Addendum # 5

Bid Opportunity: 25-7748-RFT - St. Andrew's Public School 3rd Floor Classroom Refinishing Closing Date: Wednesday, May 21, 2025 2:00 PM

Addendum #4

Addendum #:	E-1
--------------------	-----

SHEET NO:
E-202

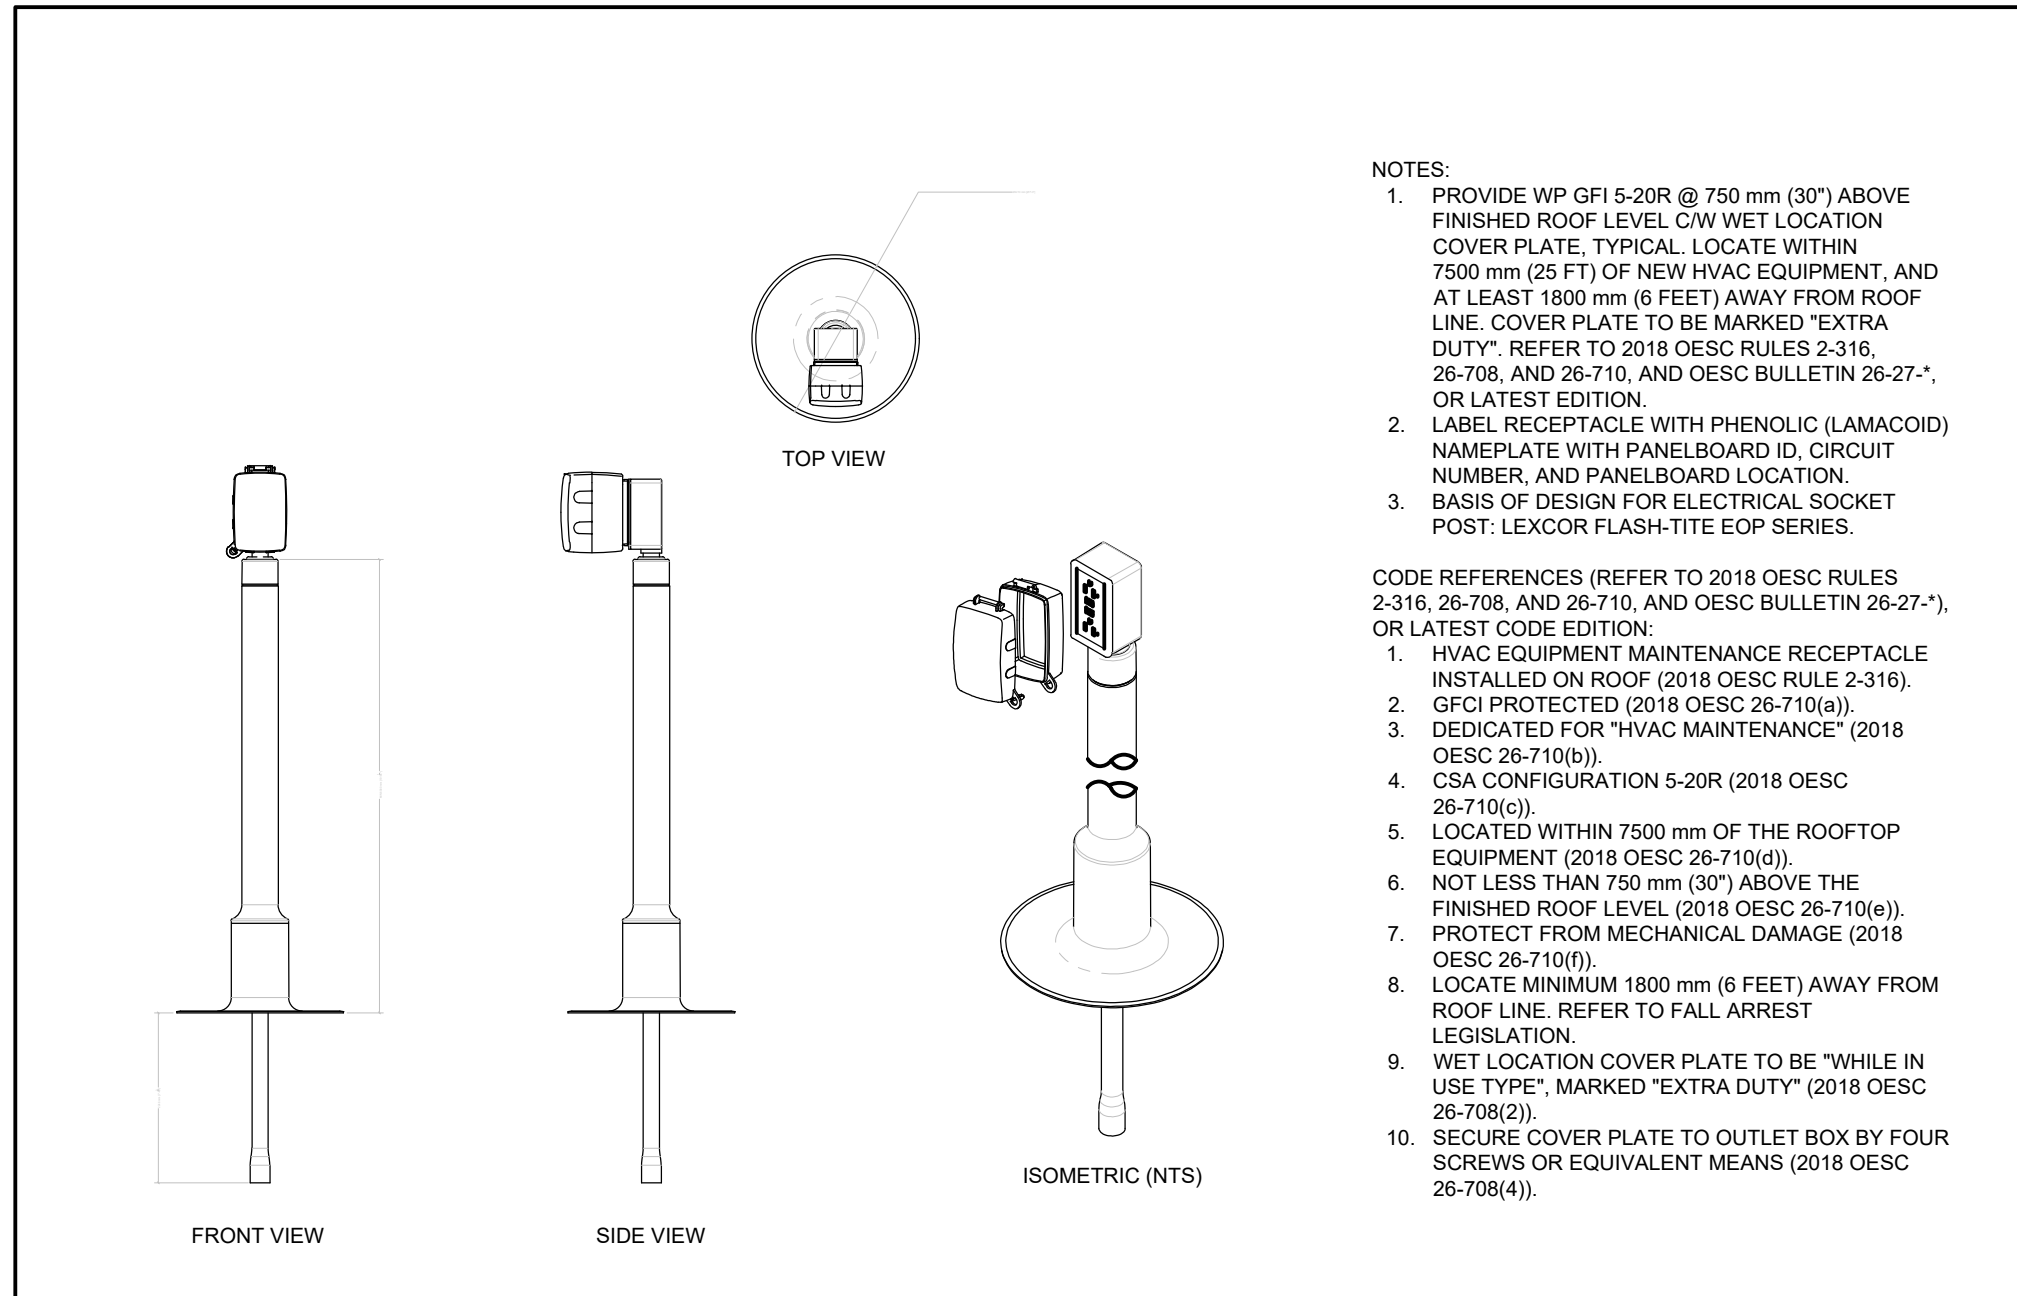
2. Drawing E-202 - First Floor New Work Plan – Power & Systems

- a. Refer to attached, revised drawing #E-202 and note revision to the routing of the new feeders to new roof mounted condensing units ‘CU-3A’, ‘CU-3B’ and ‘CU-3C’. Routing shown is diagrammatic and is to be confirmed on site prior to rough-in.
